ADDENDUM NO. 4

14-AUG-24

**IMPROVEMENTS AT GRAND LAKE STREAM STATE FISH HATCHERY
GRAND LAKE STREAM, MAINE**

BGS PROJECT NO.: 3289-14

SHEET
02D-102

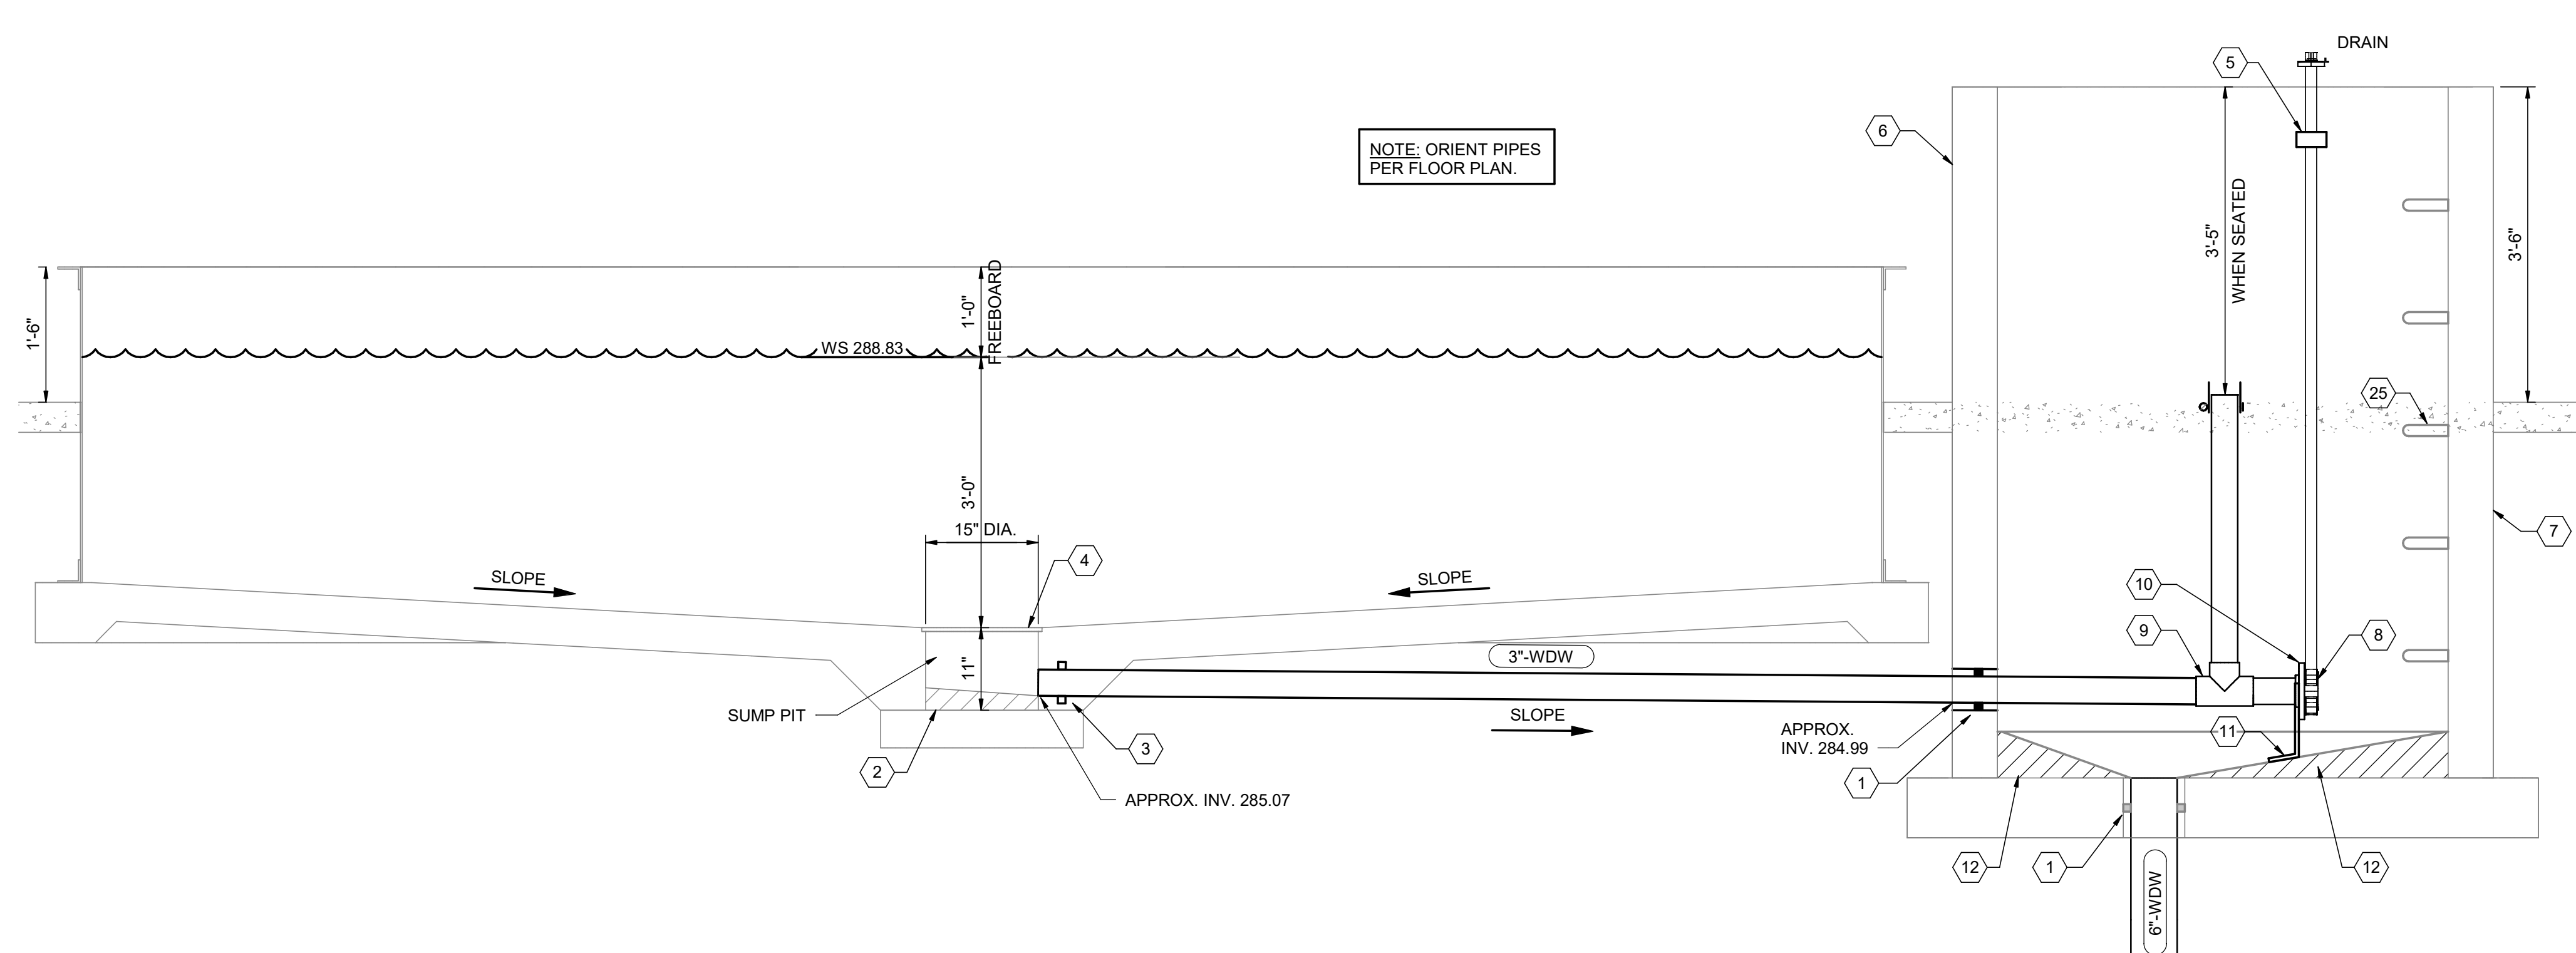
- i. **REMOVE:** "15 IN X 72 IN Nominal"
6. **SHEET 02D-102 (ATTACHED)**
 - a. **REPLACE SHEET:** Added 6"-FTD (FIELD TILE DRAIN)
7. **SHEET 02D-301 (ATTACHED)**

FTD = FIELD TILE DRAIN PIPING
 N-12-HDPE PERFORATED
 PIPE MEETING SPEC. ASTM F477
 OR EQUAL UNLESS NOTED
 OTHERWISE

0 6" 1" 2" **3 PAVILION HYDROSTATIC PRESSURE RELIEF VALVE SECTION**
02D-301 3/4" = 1'-0"

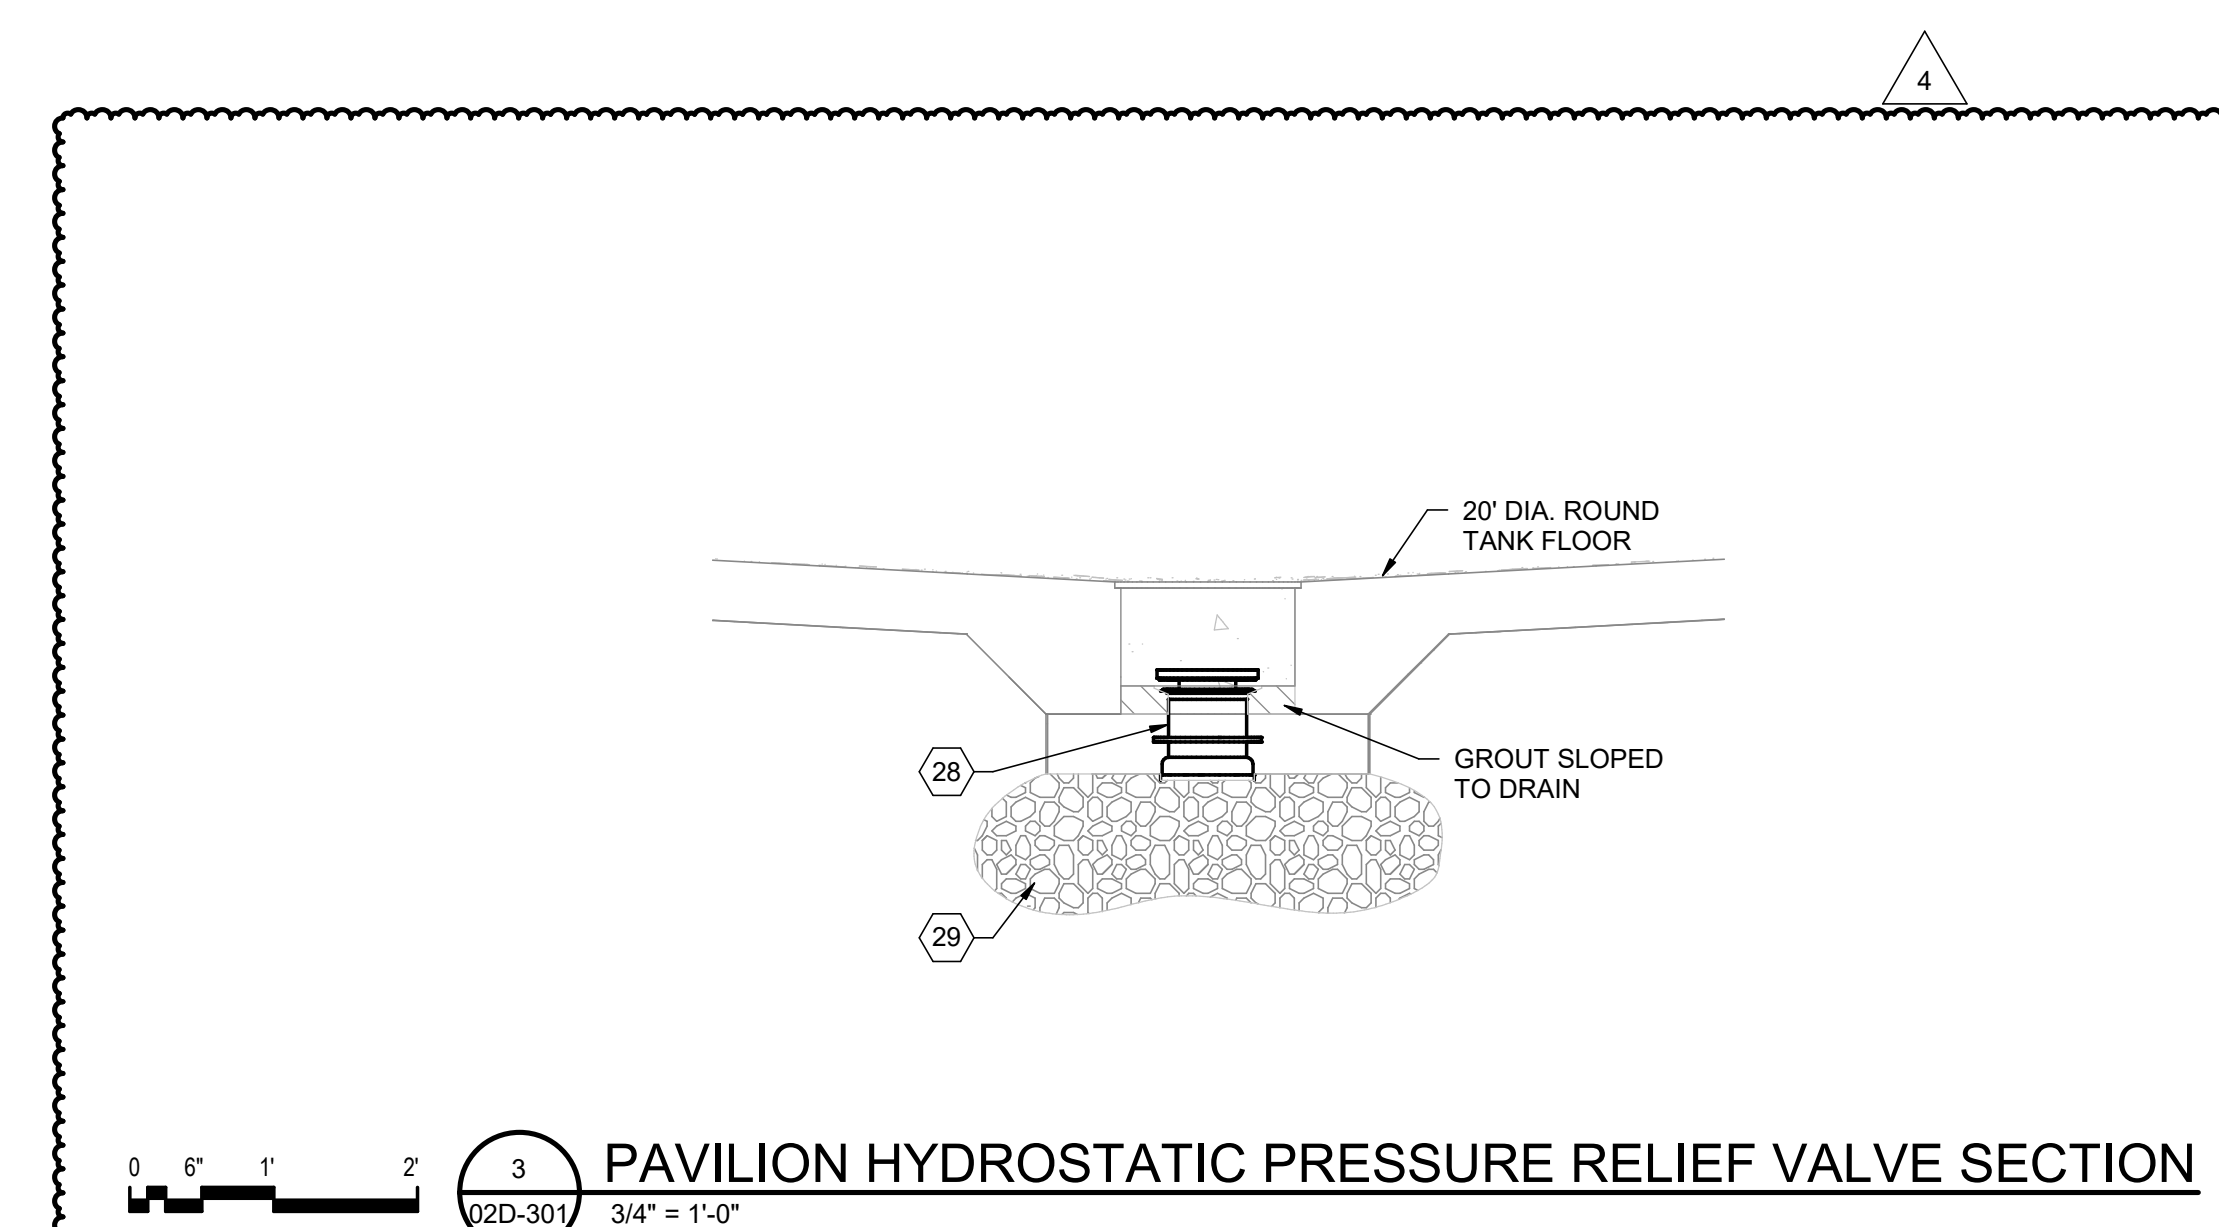
- a. **CHANGE:** DETAIL 3
8. **SHEET 03D-102 (ATTACHED)**
 - a. **REPLACE SHEET:** Added 6"-FTD (FIELD TILE DRAIN)
9. **SHEET 03D-301 (ATTACHED)**
 - a. **CHANGE:** DETAIL 3

- 25 MANHOLE STEPS
 - 26 5" SADDLE TAP W/ 1" SIGHT GLASS
 - 27 BURIED 1/2" OXY
 - 28 4" FLOOR MOUNTED HYDROSTATIC PRESSURE RELIEF VALVE EQUAL TO PENN-TROY A2550RSN/4
